Natural Forest Standard Forest Project Annual Verification Report

TROCANO ARARETAMA CONSERVATION PROJECT

Report Date: 13 August 2014

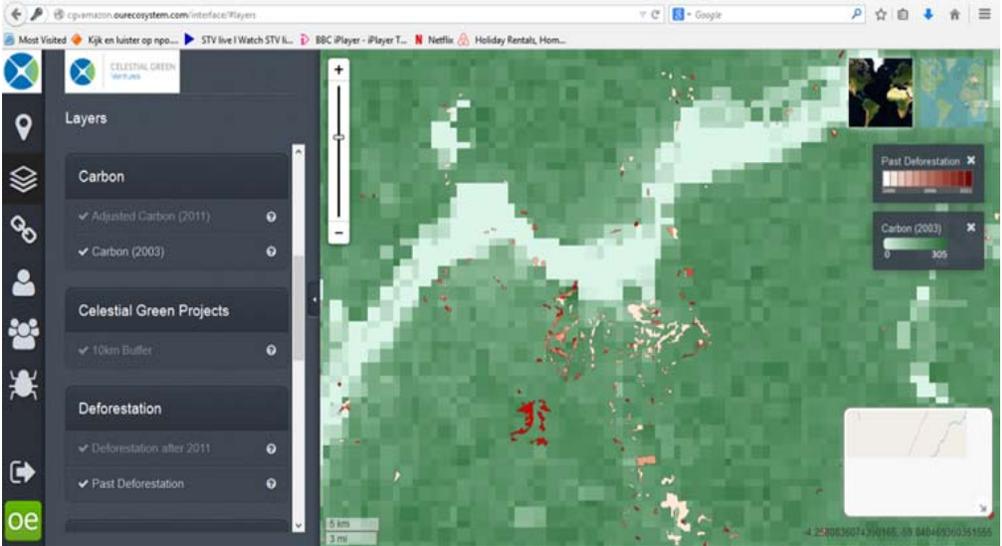
13 - NCR
NFS Requirement:	Ensure that the data used for quantification is correct and appropriate.
ESI Finding:	Fire events during the current crediting period do not appear to have been accounted for and simply presented as occurring as stated in section 7.1.5 of the Implementation Report. Implementation report states "Fire events are recorded by the MODIS instrument on board the NASA Terra (EOS AM) Satellite9. A density map (no. of events/sq.km) was created based on the Global 10-day fire maps from recorded fire events in each year for 2005 to 2010. The results are given in a bar chart." Verifiers believe that the coarse resolution employed in the project to detect deforestation is insufficient to detect fire ignition sources and burnt area size. However, the methodology does not appear to account for emissions estimates from fires.
Evidence:	Trocano Project Implementation Report_2_DRAFT COPY_290514.pdf

Request:	NCR: As fire is a known factor in deforestation pressures in the Amazon, please explain how the results of the MODIS hotspot data are incorporated into emissions estimates. Please also justify the choice of MODIS for fire ignition monitoring and whether it used to estimate burnt area size in the reporting period.

Response:	It is confirmed that fire events are neither accounted for nor included within the project emissions estimates for the Trocano project, as it is not a requirement of the approved NFS methodology AM001.1b. The Past Fire events data within the Geospatial Platform, the explanation of those results in the “Summary of Quantification Calculations and Methodologies” document and the corresponding section within the PIR are included for background information purposes only, to provide general information on the number of historical fire events within project and leakage areas prior to the start of the project.

<p>By not including fire events within the calculations, the quantification process is consistent with the approved NFS Methodology, and as such it is deemed that this should not be included as a valid NCR.</p> <p>However, having reviewed the inclusion of this information for the purposes of responding to this NCR, it is concluded that including this information in the current PIR may be confusing and infer that fire events have been accounted for, which is not a requirement of the Standard or the NFS Methodology. The Past Fire Events information has therefore been removed from the PIR to avoid further confusion. The data will however remain in the Geospatial Platform for the pre-project information purposes detailed above.</p> <p>This pre-project information was derived from point data available from the Fire Information for Resource Management System (FIRMS) who provide global fire locations based on MODIS data. These data were used to create fire density maps. As they are derived from point data, they would only show numbers and approximate locations of historical fires and can't be used to estimate fire or burn scar extents. Other data sources exist that can be used to derive burnt area estimates if and when it becomes a requirement to do so.</p>

Final ESI Finding:	<p>Verifiers accept this response and observe that fire is not part of carbon accounting in the methodology. It has also been confirmed to have been removed from the PIR. However, photos 22-24 (photo 25 is noted but does not exist) in the PIR seem to suggest that fire is a driver of deforestation in the region. Perhaps it is more clear if fire is included in the context of land clearing activities if the photos are to remain. Finding closed.</p> <p>OFI: Fire could be incorporated into carbon accounting to more accurately portray standing carbon stocks.</p>
NCR/CL/OFI Closed	25 June 2014
